From: Mess, Camie
Sent: Friday, January 26, 2018 4:07 PM
To: Whitney Hudson (whudson@bdarchitects.com)
Subject: BAR Action- January 17, 2018 - 600 West Main Street

Certificate of Appropriateness Application
BAR 16-01-04
512-514, 600 West Main Street
Tax Parcel 290007000, 290006000, and 290008000
Heirloom West Main Development LLC, Owner/Heirloom West Main Development LLC, Applicant
Changes of material from Approved COA

**CITY OF CHARLOTTESVILLE
BOARD OF ARCHITECTURAL REVIEW
STAFF REPORT
January 17, 2018**

Re: 510-600 West Main Street: BAR approval request for substitution of exterior cladding materials

* BAR - APPROVED MATERIAL AND COLOR
** BAR - APPROVED MATERIAL

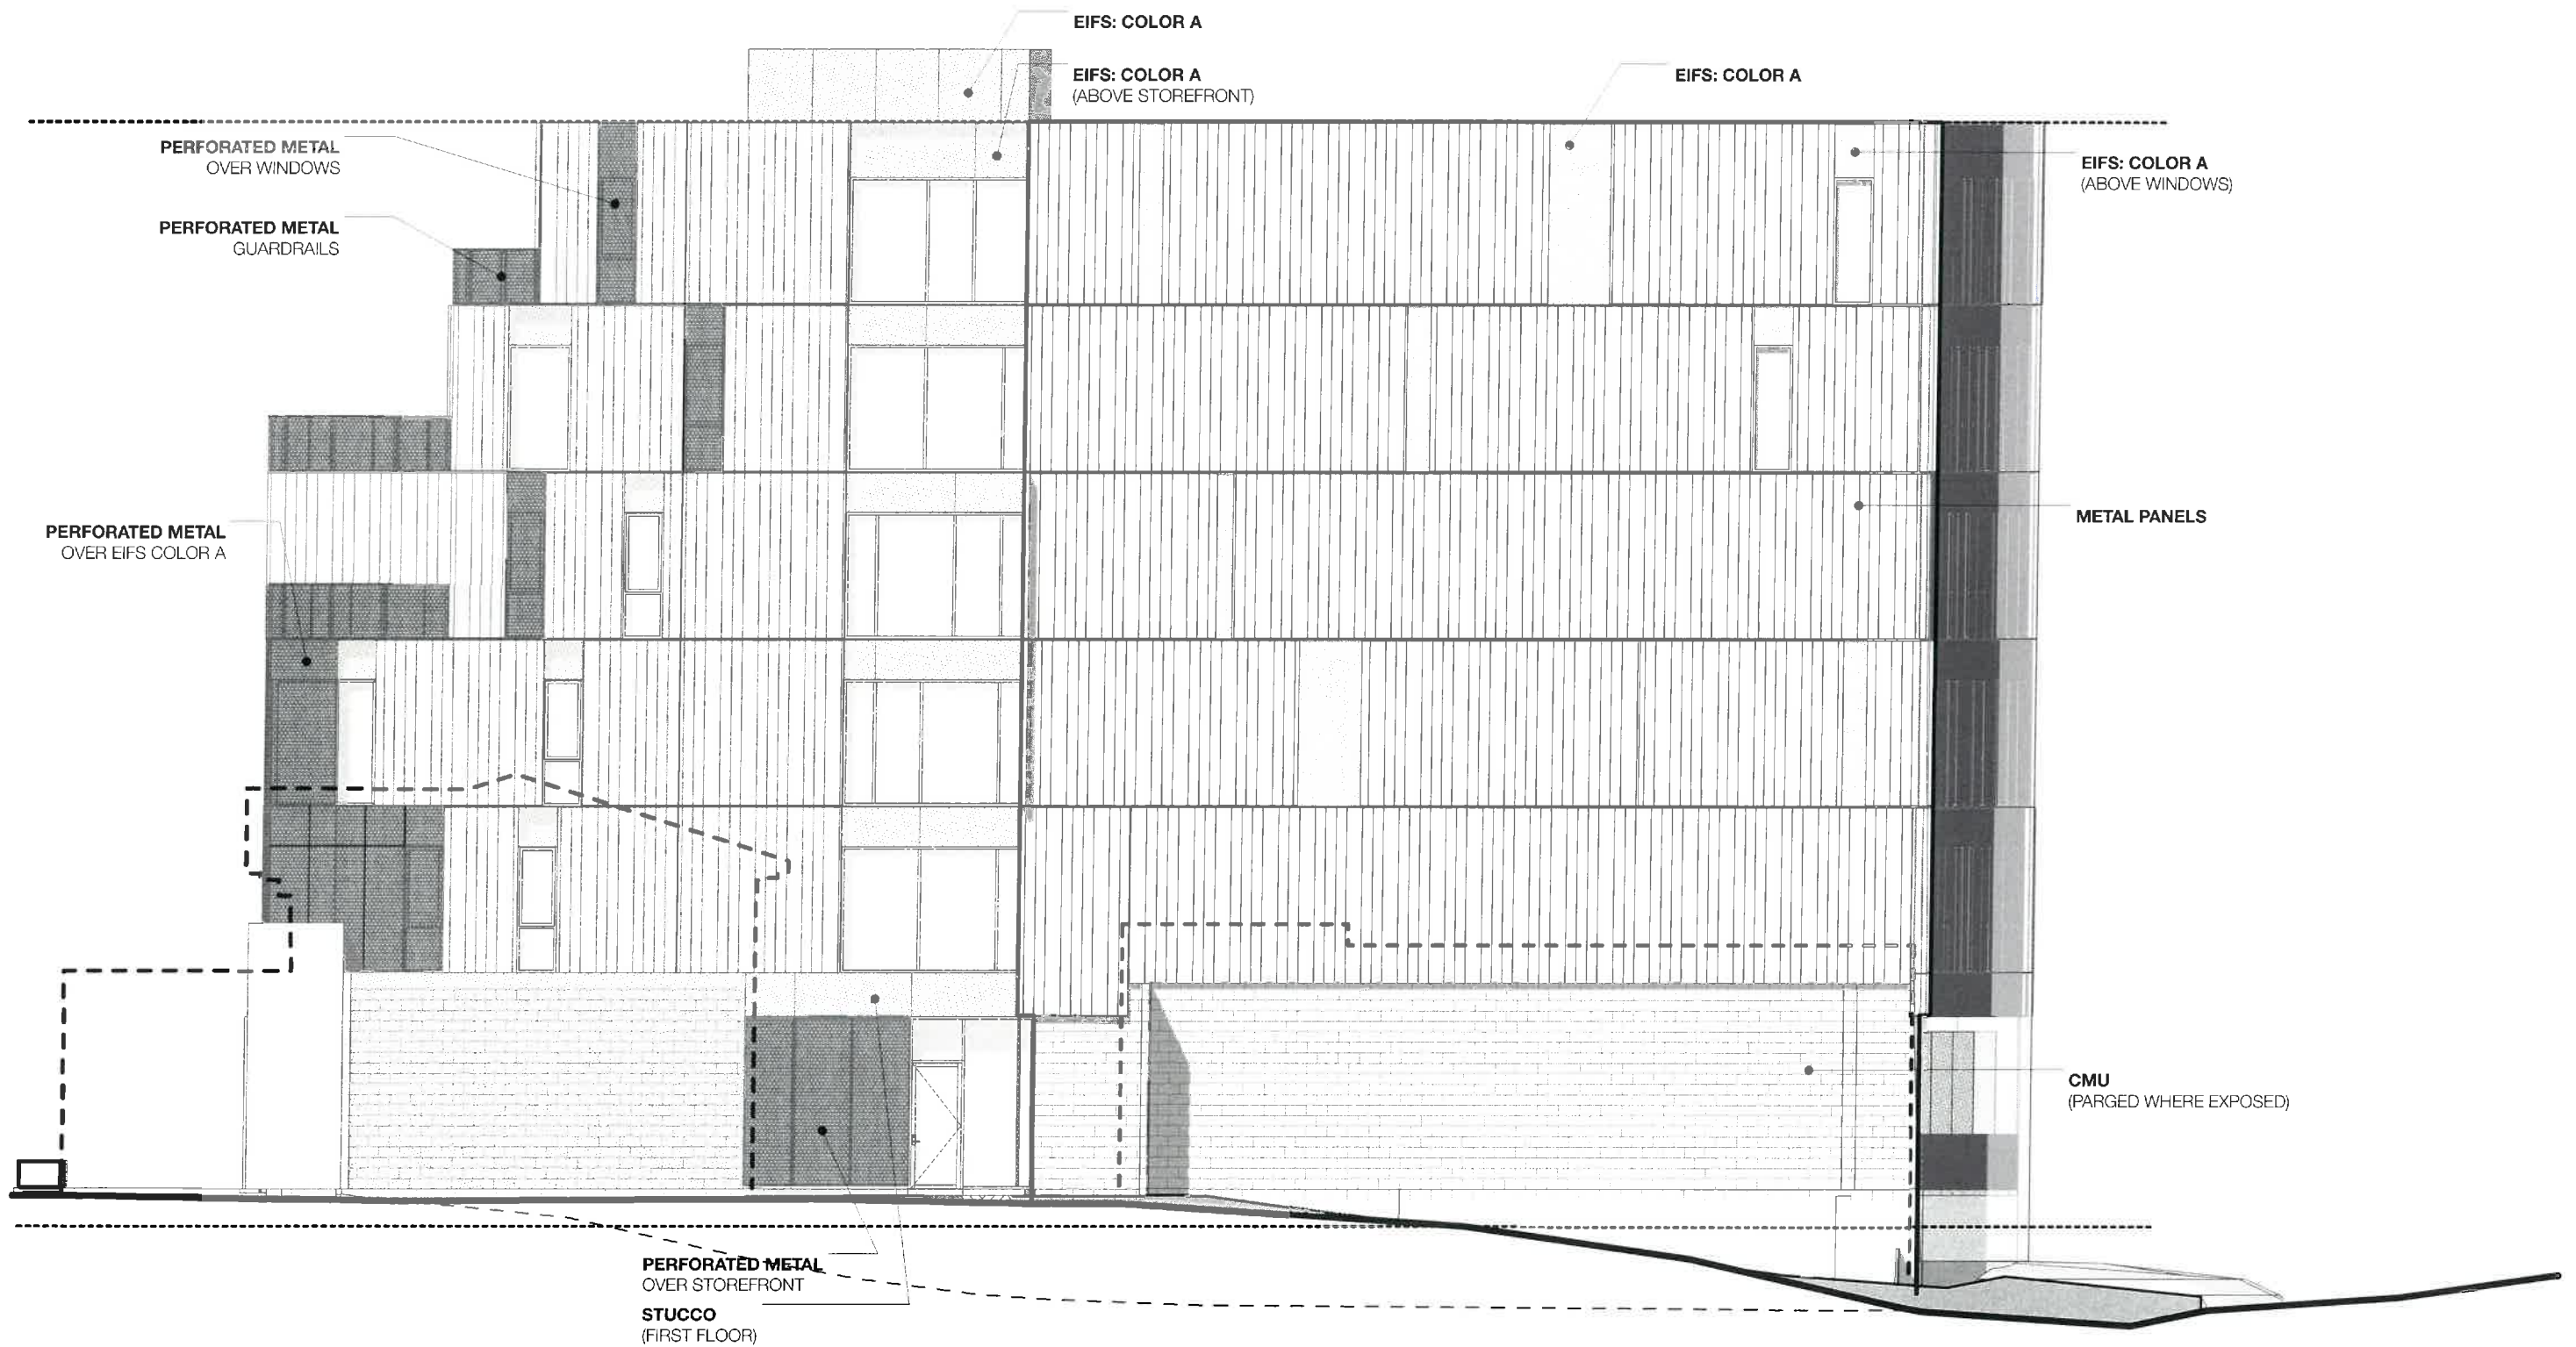
STUCCO
color: SW7642 Pavestone
texture: smooth fine sand
(proposed substitute for fiber cement C)

EIFS A
color: SW7069 Iron Ore
texture: savannah
(proposed substitute for fiber cement A)

EIFS B
color: BM HC166 Kendall Charcoal
texture: savannah
(proposed substitute for fiber cement B)

perforated metal color
RAL 7037 SD Matte

NORTH ELEVATION - COURTYARD

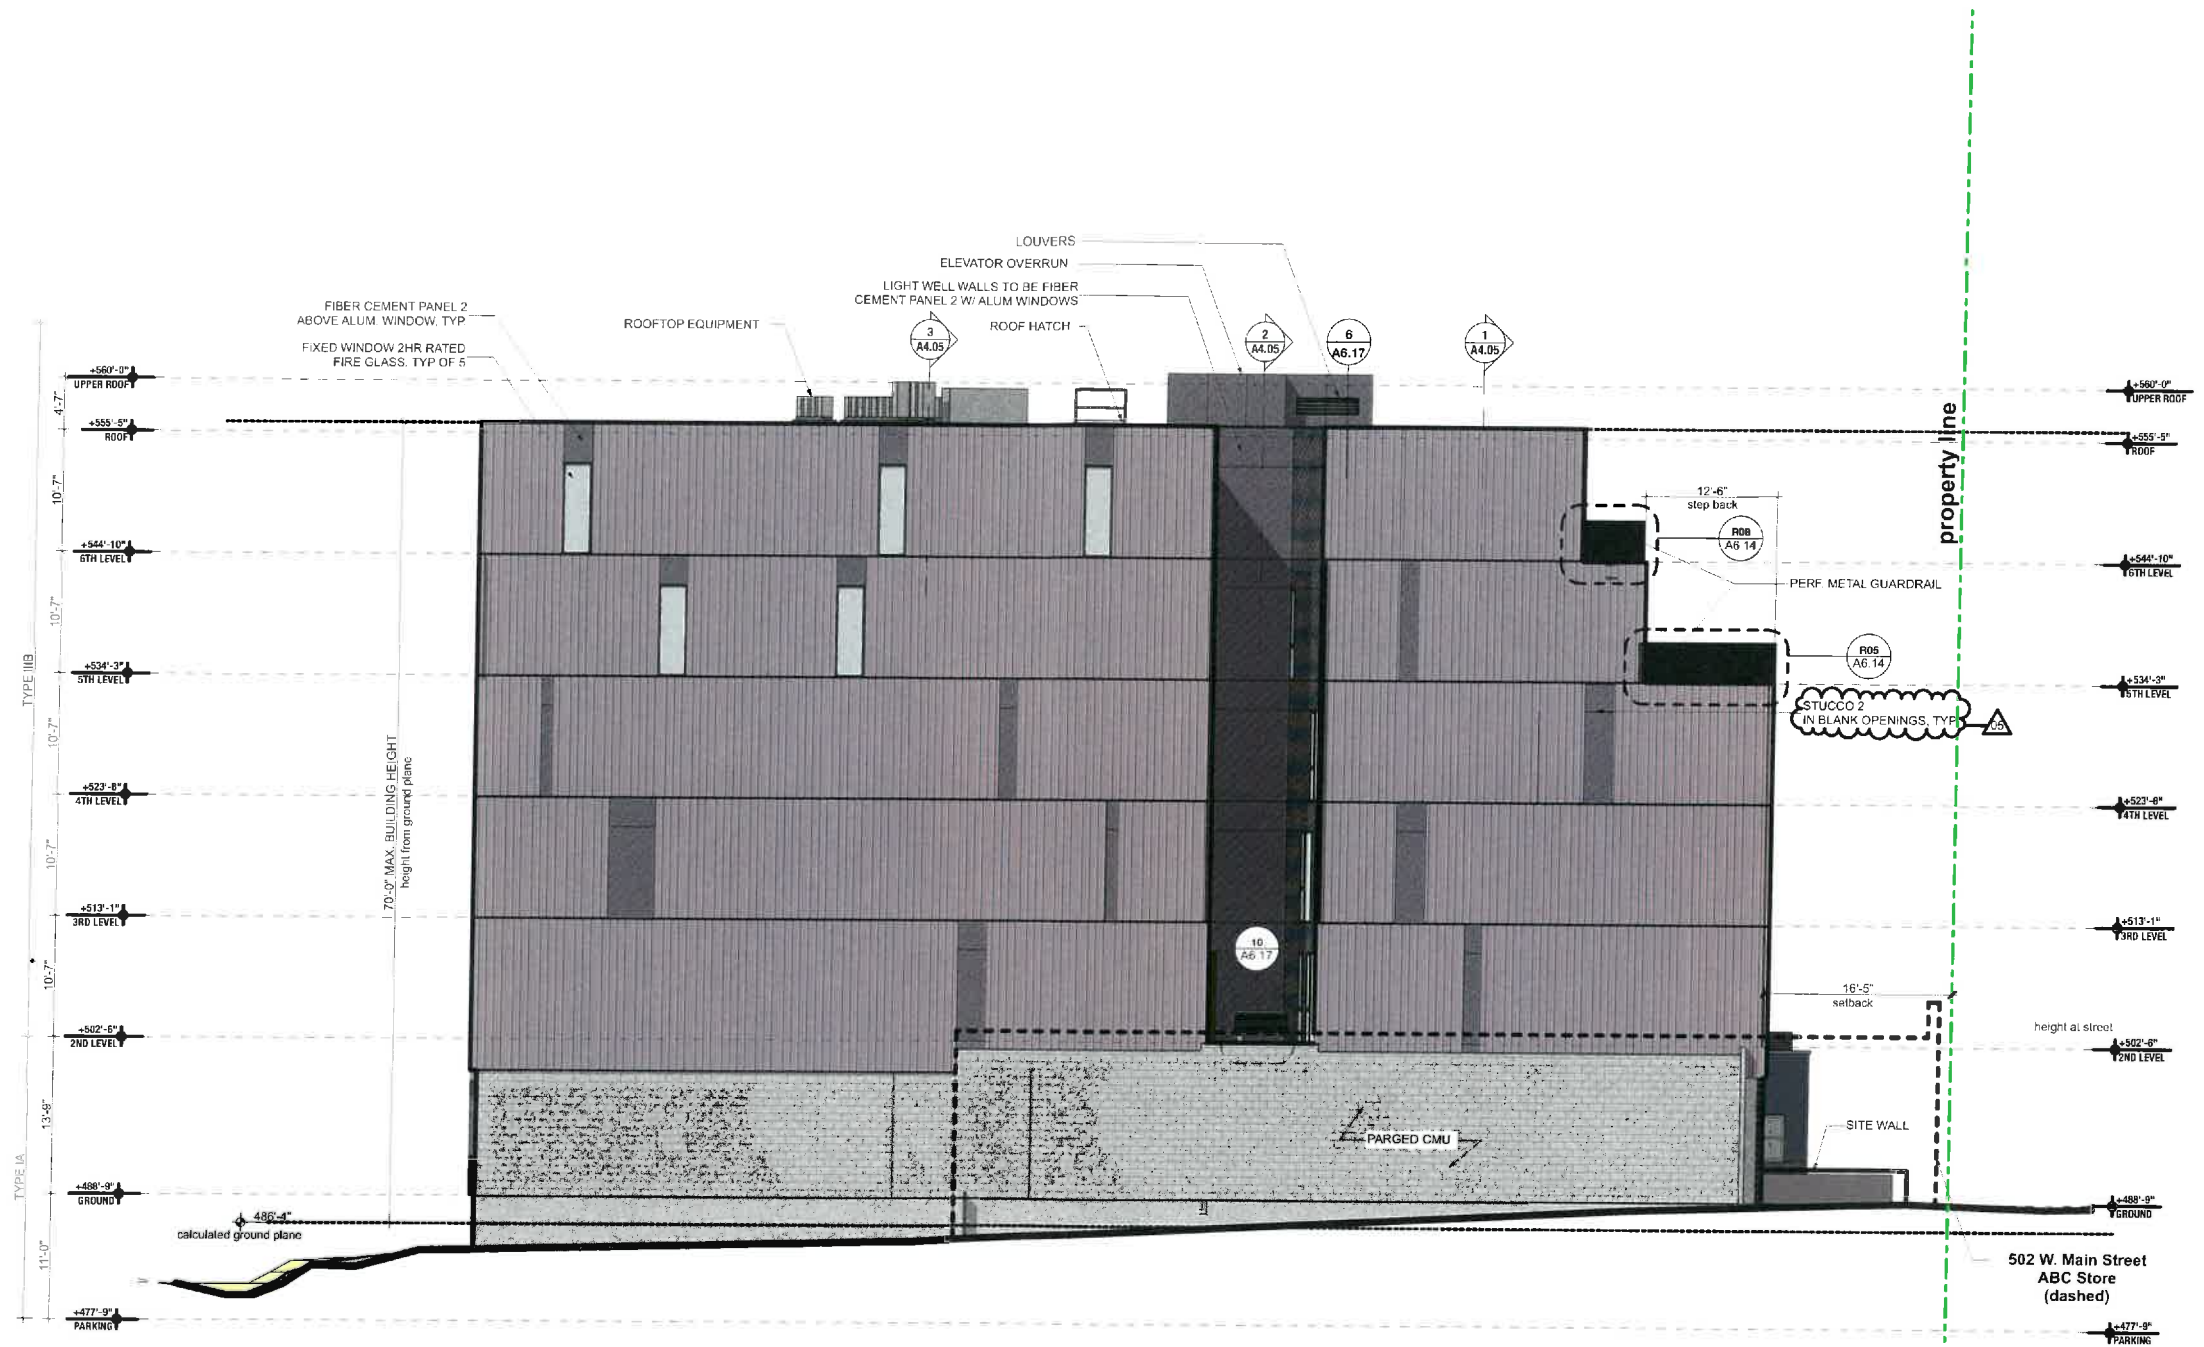
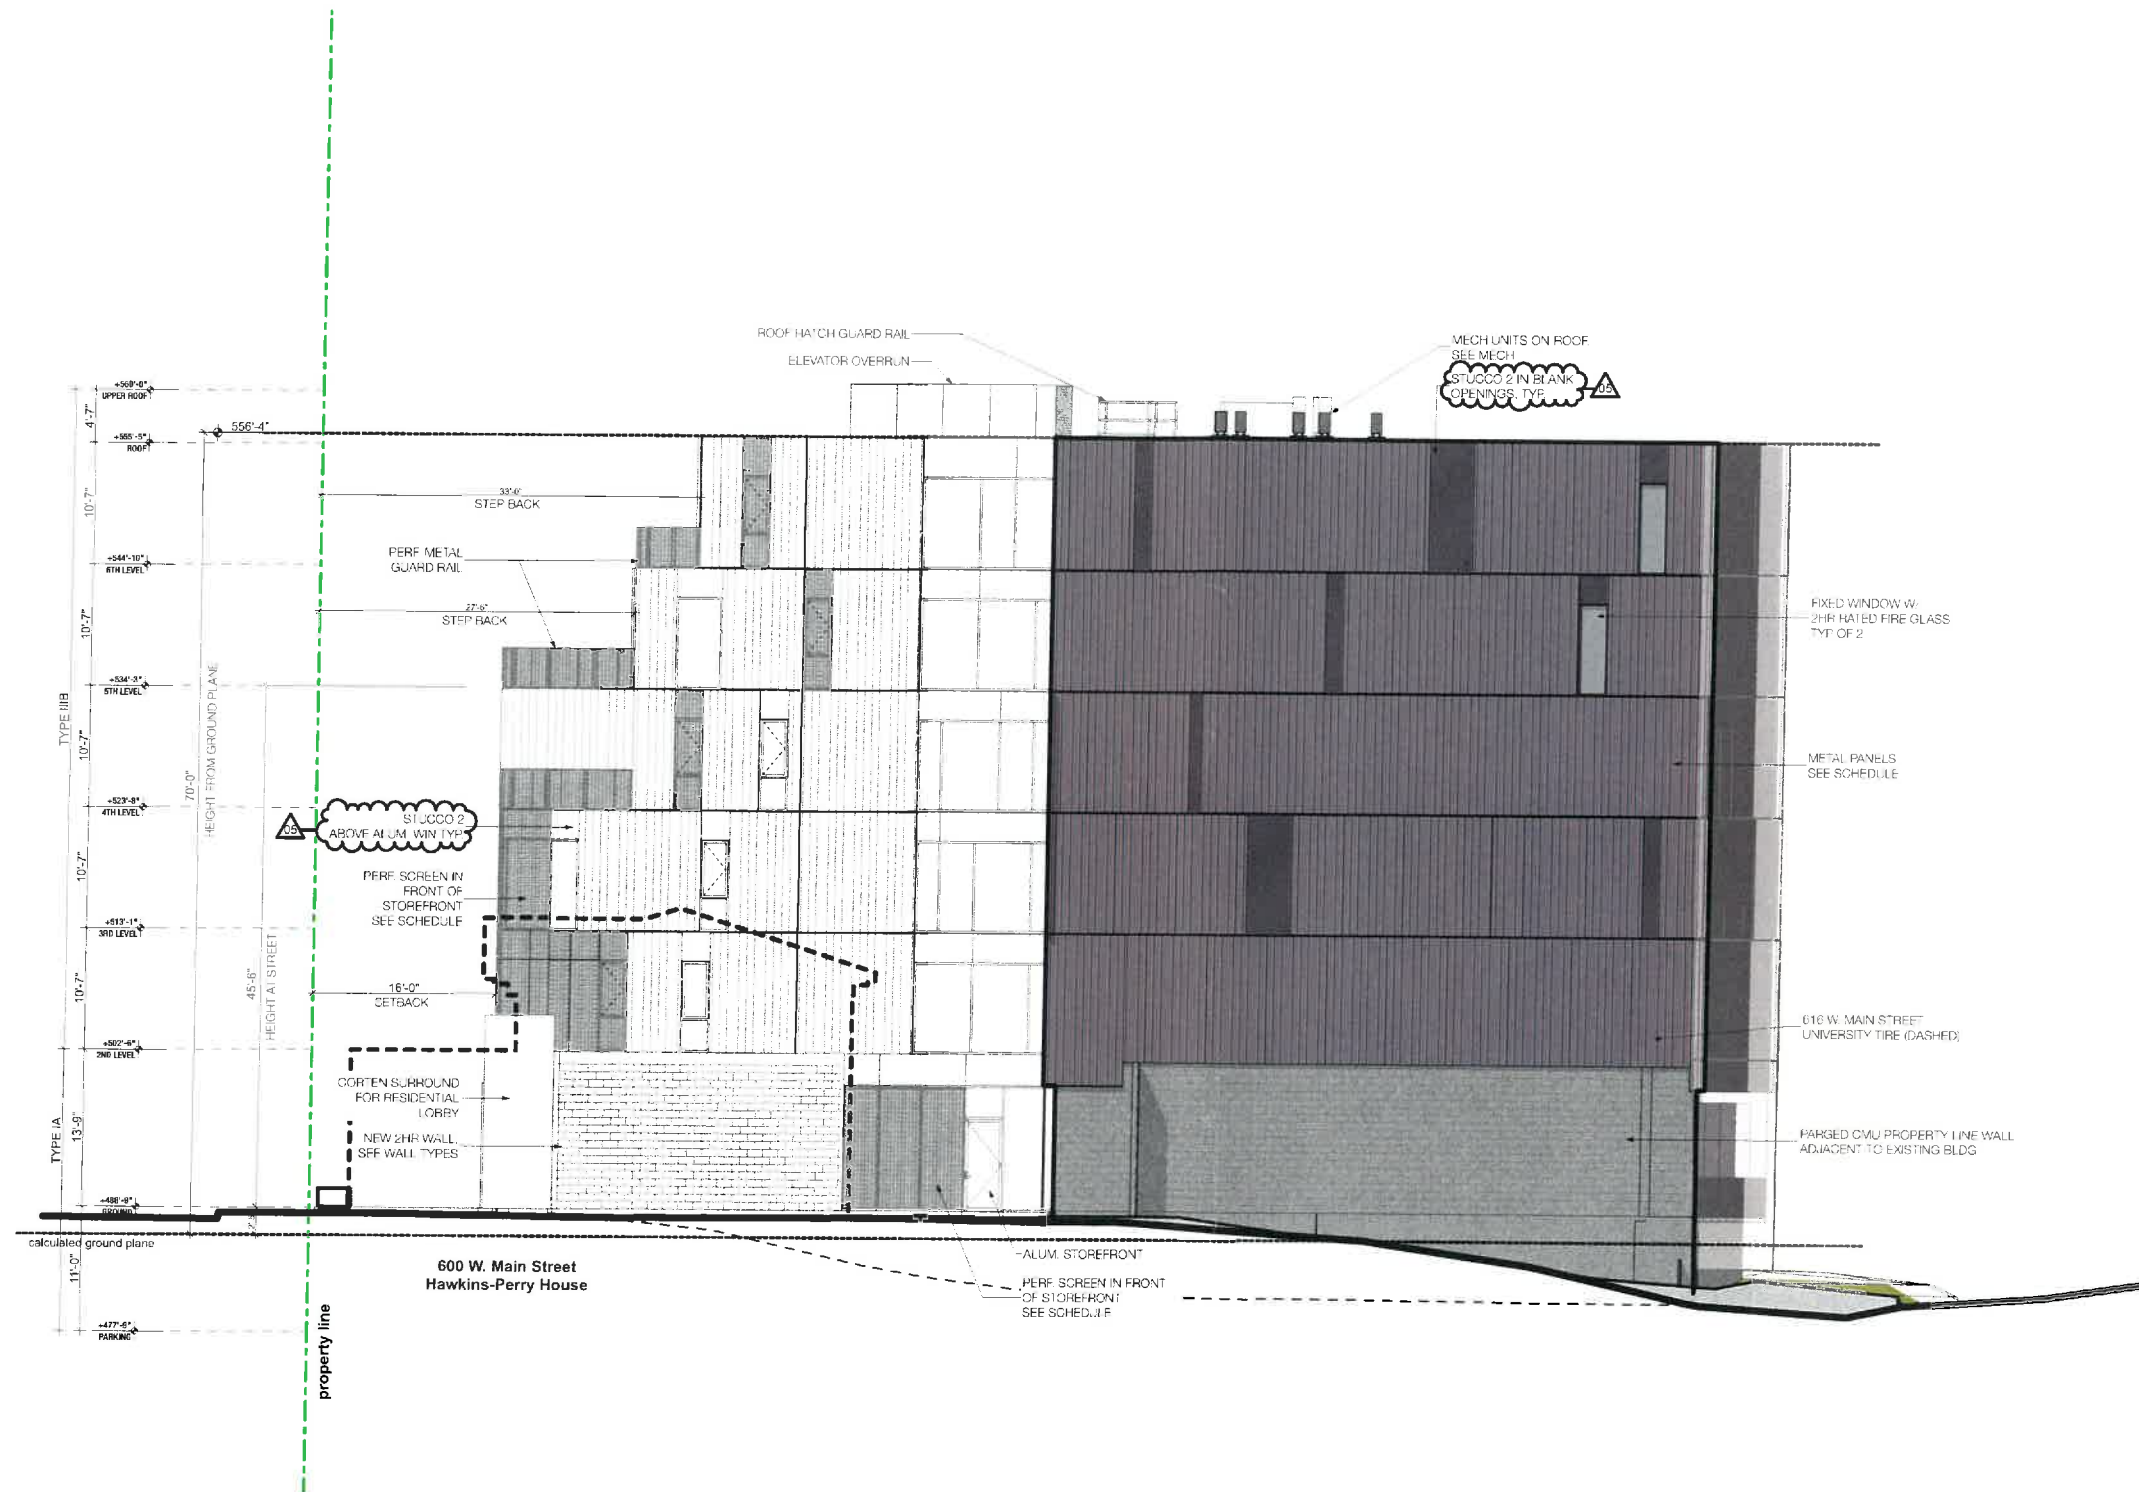
In the approved design we had a Cembonit Fiber Cement Panel material on the first floor. We propose to change this to a smooth stucco finish. This change will have very little visual impact because most of the material is under perforated screen.

- The finish will be more natural and variable.
- We will be able to eliminate a horizontal joint on each floor, which was required by the Hardie Panels. This change will make the joint pattern of the southern façade more in keeping with the other sides of the building.
- The insulation will add a layer of sound absorption for the southern railroad-facing façade.

The original design showed vertical metal panels with perforated metal used over windows, on the street façade, for the garage door and for guardrails. The solid metal and perforated metal were to match. Due to manufacturing differences we cannot get the perforated panels in the matte/zinc-look finish we wanted. We have worked to find a paint and a finish that we think will be very similar.

Mohr moved: Having considered the standards set forth within the City Code, including City Design Guidelines for New Construction, I move to find that the proposed amendments to the Certificate of Appropriateness satisfies the BAR's criteria and are compatible with this property and other properties in the West Main Street ADC District, and the BAR approves the application as submitted, with the request that the applicant submits design details of how the lower stucco meets the ground. Balut seconded. Approved (4-2, with Miller and Schwarz opposed.)
